V2500 Propulsion System — Nacelle

SERVICE BULLETIN

NACELLE - POWER PLANT - DRAINS MAST,
BOLTS - REPLACEMENT OF

V2500-NAC-71-0017
Page 1 of 9

Replacement of the Bolts which Attach the Drains Mast
Figure 1

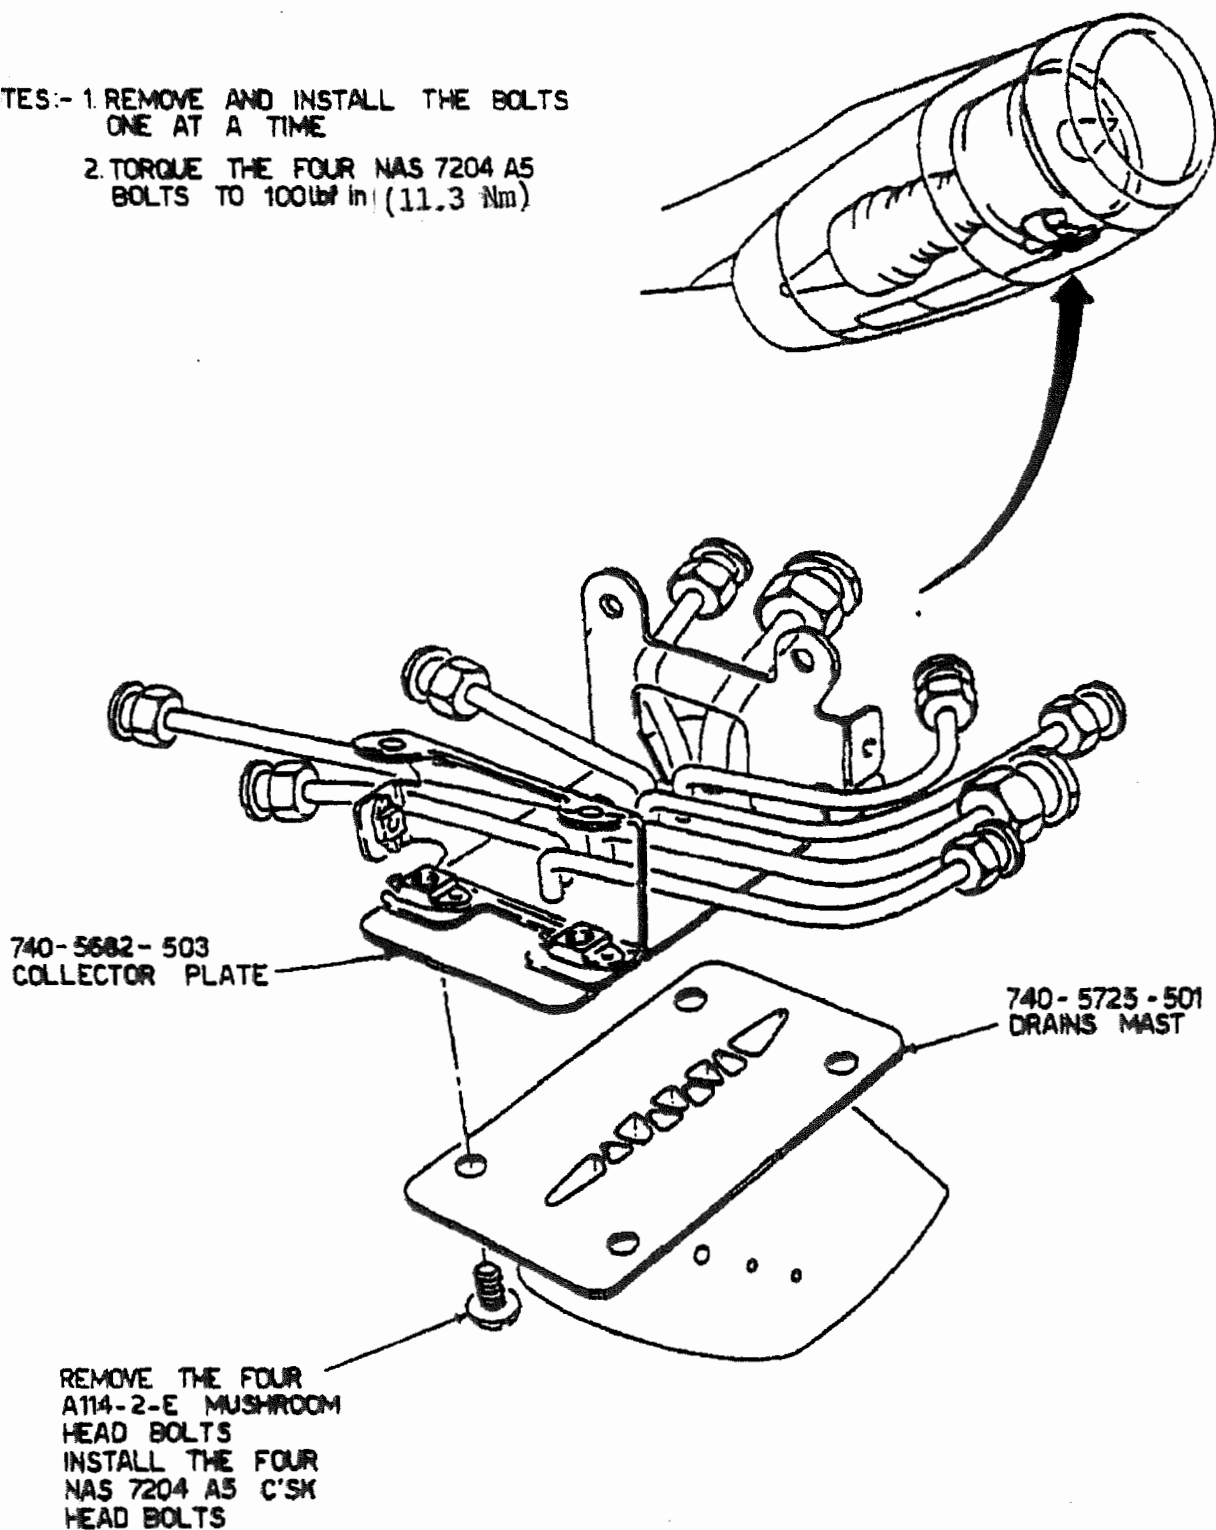
The drawing shows four mushroom head bolts for the installation of the drains mast. It is not possible to install mushroom head bolts in the cast drains mast because the four bolt holes have been countersunk. Countersink head bolts must be used.

The four A114-2-E mushroom head bolts are replaced by four NAS7204 A5 countersink head bolts to attach the 740-5725-501 drains mast.

- (1) Replace the four bolts which attach the 740-5725-501 drains mast and the 740-5682-503 collector plate to the engine as follows:
 - (a) Remove the four A114-2-E mushroom head bolts from the drains mast. Install the four NAS7204A5 countersink bolts in the drains mast. (Refer to Figure 1.)

- (b) Torque the four NAS7204A5 countersink head bolts to 100 lb-in. (11.3 N.m) as specified in the V2500 Aircraft Maintenance Manual, Task 70-23-11-911-010.

NOTES:- 1. REMOVE AND INSTALL THE BOLTS
ONE AT A TIME

2. TORQUE THE FOUR NAS 7204 A5
BOLTS TO 100lb_f in (11.3 Nm)
